SUNDRY NOTICES AND REPORTS ON WELLS (DO NOT USE THIS FORM FOR PROPOSALS TO DRILL OR TO DEEPEN OR PLUG BACK TO A DIFFERENT RESERVOIR. USE "APPLICATION FOR PERMIT" (FORM C-101) FOR SUCH PROPOSALS.) 1. Type of Well: Oil Well <input type="checkbox"/> Gas Well <input type="checkbox"/> Other <input checked="" type="checkbox"/> SWD		WELL API NO. 30-025-52782 5. Indicate Type of Lease STATE <input type="checkbox"/> FEE <input checked="" type="checkbox"/> 6. State Oil & Gas Lease No.

2. Name of Operator BC&D OPERATING, INC.		7. Lease Name or Unit Agreement Name Javelina 34 25 37 SWD
3. Address of Operator 2702 North Grimes, Ste.B, Hobbs, NM 88241		8. Well Number 1

WELL SCHEMATIC - PROPOSED
Javelina 34-25-37 SWD #1

Drilling Plan Revision

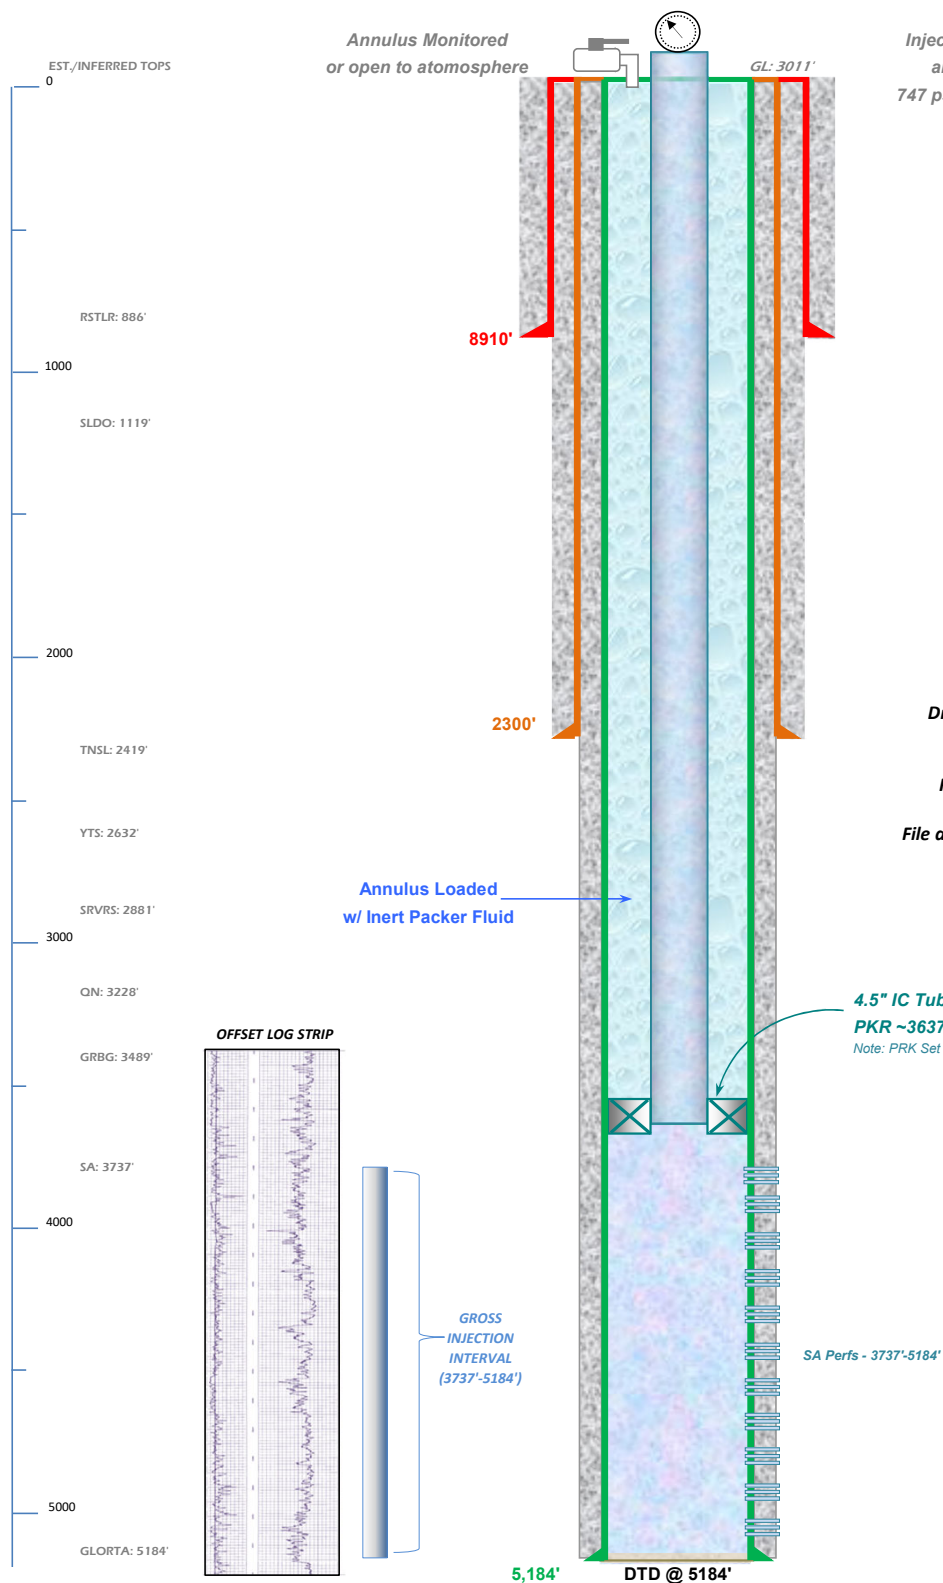
BC&D will change [upsized] the approved surface casing from 10-3/4" to 13-3/8" to the approved depth of 890' w/ 420 sx circulated. A NEW intermediate string will be added - 9-5/3" casing will be set at ~2300' and cemented with 800 sx and circulated to surface. The approved 7.0" production string will remain as approved; set at ~5184' cemented with 700 sx and circulated to surface.

The surface casing will be upsized from 10-3/4" to 13/38" set to 890' and cemented w/ 425 sx circulated to surface.

An intermediate string of 9-5/8" casing will be set at ~2300' and cemented with 800 sx and circulated to surface.

The production string of 7.0" will remain unchanged as approved on the current C-101.
